Re: **Modification No. 2 to the Remedial Design Report/Modification No. 1 to the Leaching Analysis Report, Revision 1**
Expansion of Central Valley Area
Three Kids Mine, Henderson, Nevada

Responses to NDEP Comments made on October 8, 2024 to the Modification No. 2 to the Remedial Design Report/Modification No. 1 to the Leaching Analysis Report, Expansion of the Central Valley Area, dated September 20, 2024

Subject: Modification No. 2 to the Remedial Design Report/
Modification No. 1 to the Leaching Analysis Report
Expansion of the Central Valley Area, Revision 1
Three Kids Mine Site, Henderson, Nevada

Figure 6 (Revised)

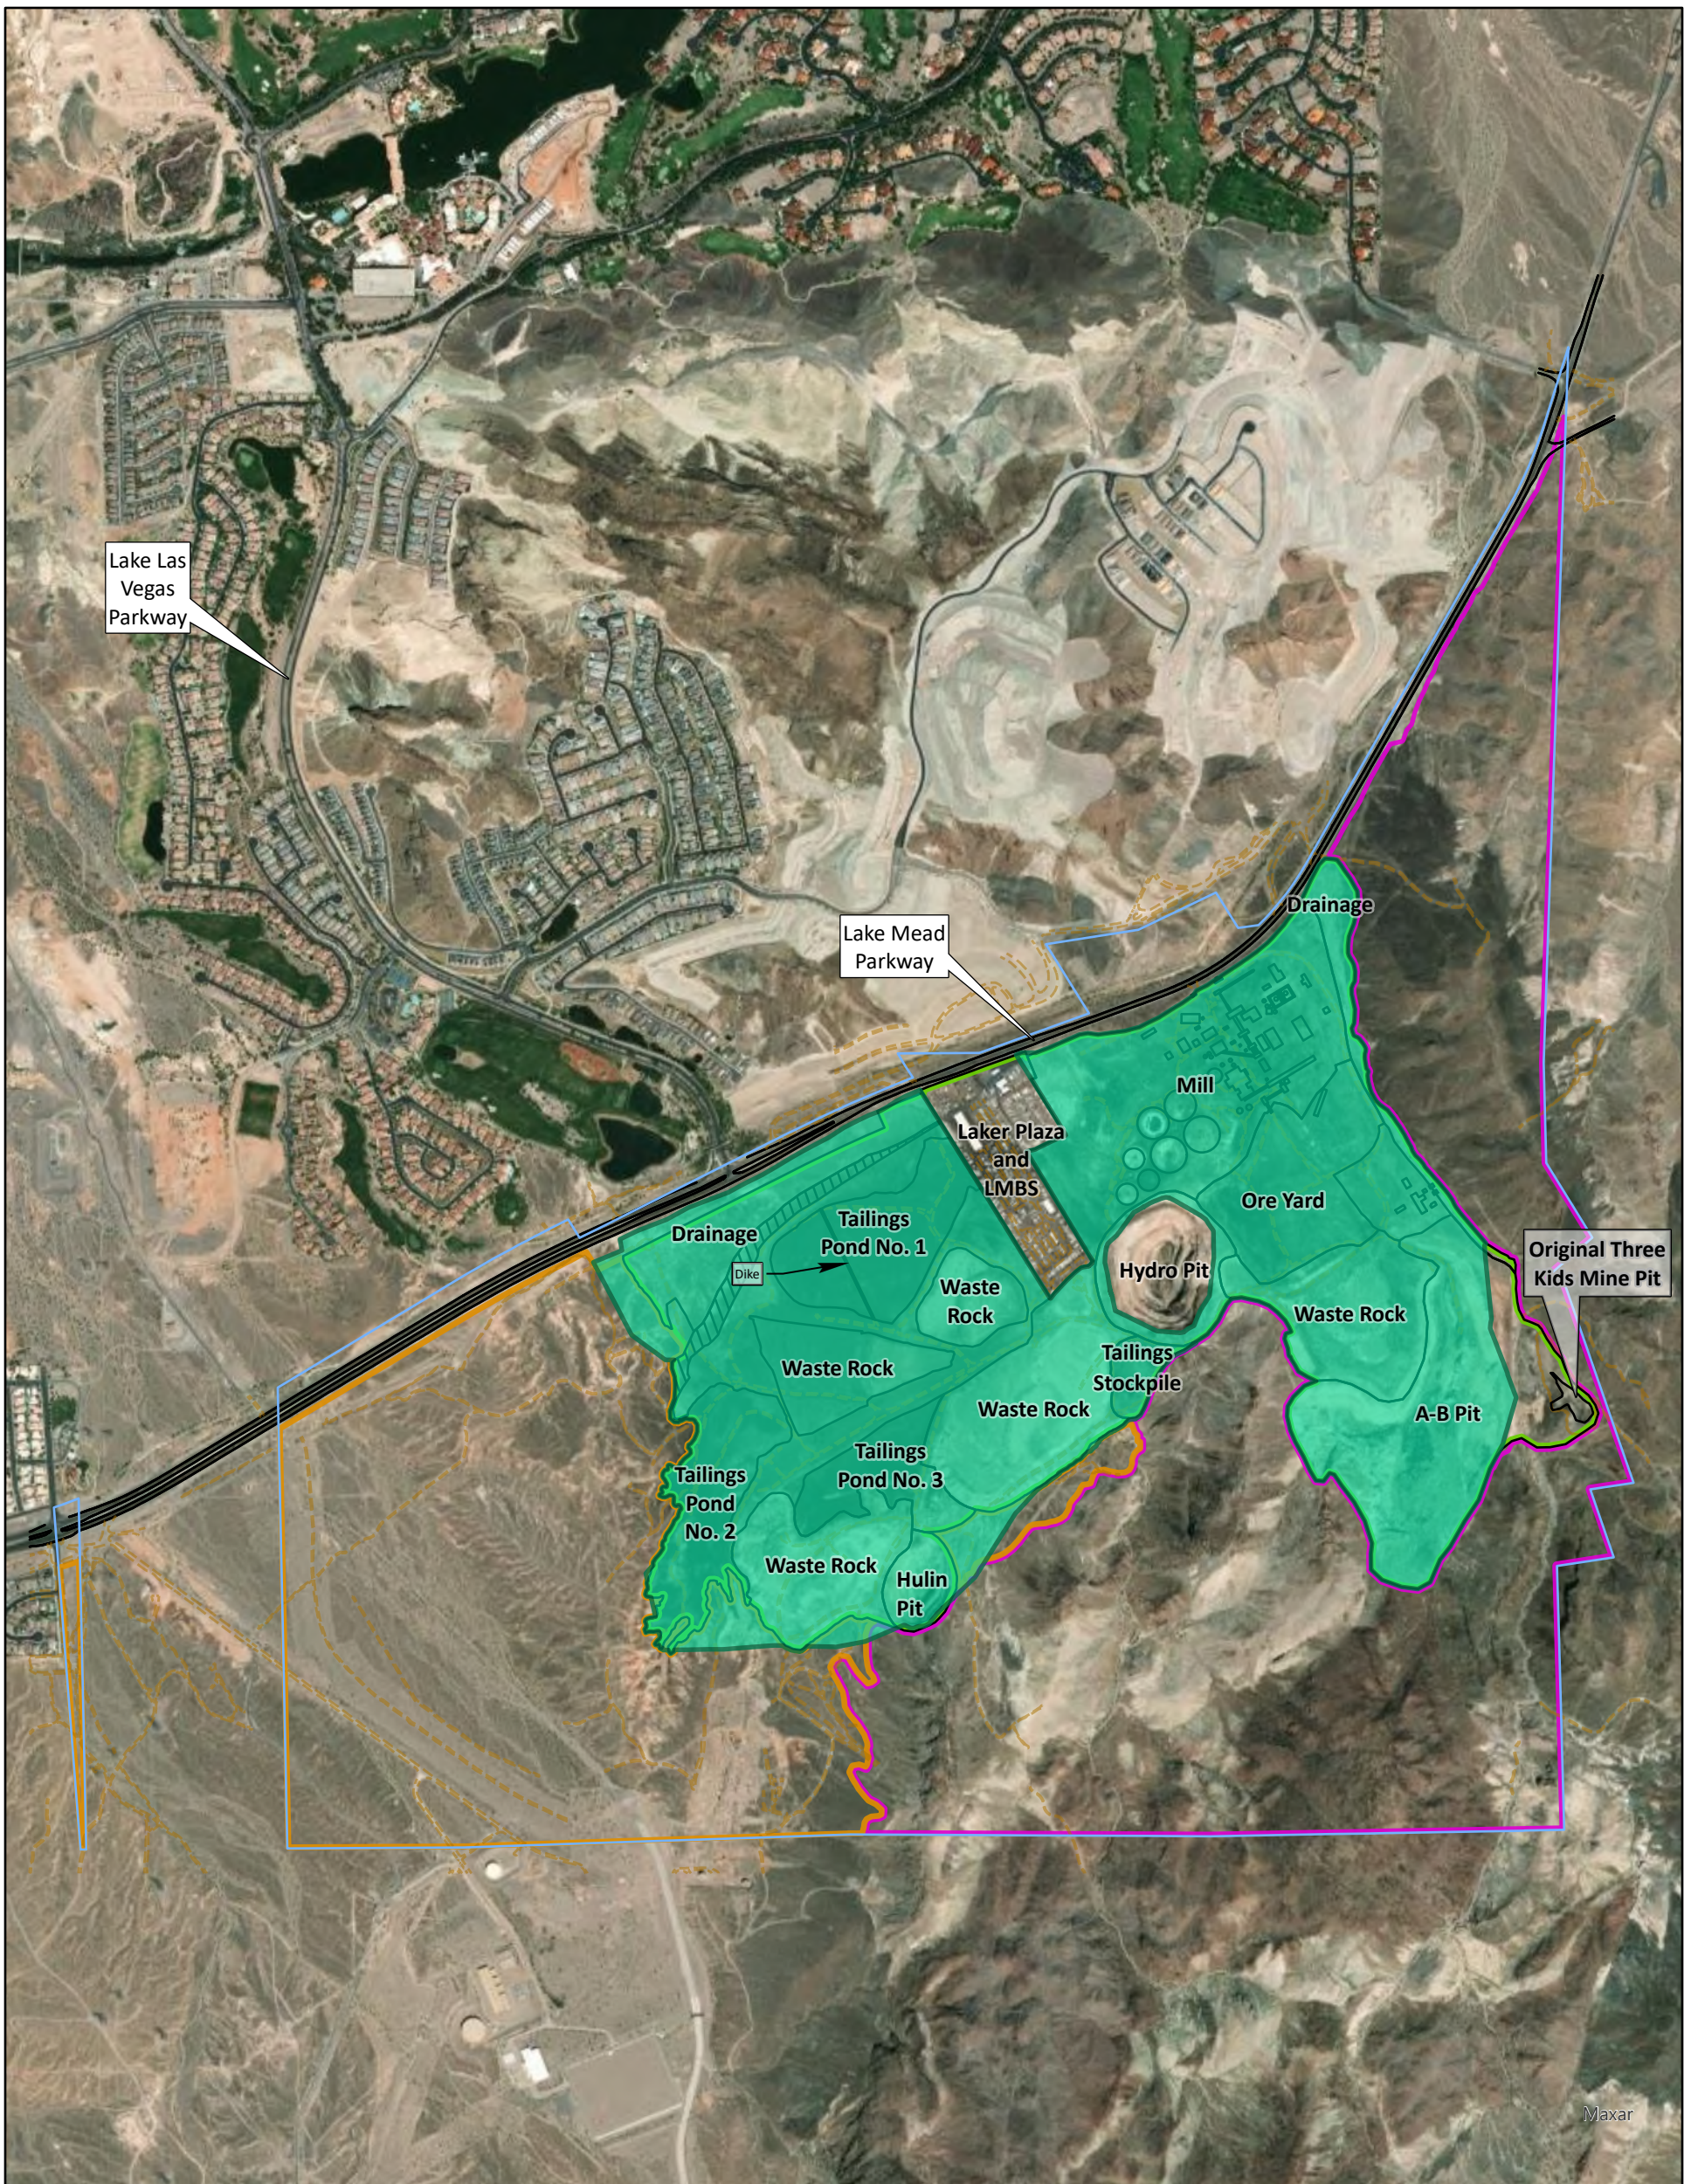
- b. The technical memorandum should also explain the reason why deep fills are anticipated in the mill site, ore yard, and other areas included in the revised Central Valley Area depicted in Figure 6.

- c. In addition to deep fills in areas not previously anticipated, is the depth of the waste rock fill going to increase in previously planned areas? In other words, are deeper fills also anticipated in areas located within the boundary of the original Central Valley Area (e.g., tailings pond 3, waste rock areas, and western portion of drainage area north of tailings pond 2).

- a. Correct, tailings are not known to be present at the mill site. The mill site was removed from the sentence referenced, and the reason for requesting use of waste rock as fill below 10 ft in the mill site and ore yard was clarified in a separate, following sentence.
- b. See sentence added per comment 1a.
- c. The Central Valley Area model scenario presented in the Leaching Analysis Report considered waste rock used as fill up to 40 ft. The anticipated depth of waste rock fill increased as a result of recent findings. An increase in the maximum depth of waste rock fill will be covered in a separate modification that includes remodeling the Central Valley Area scenario.
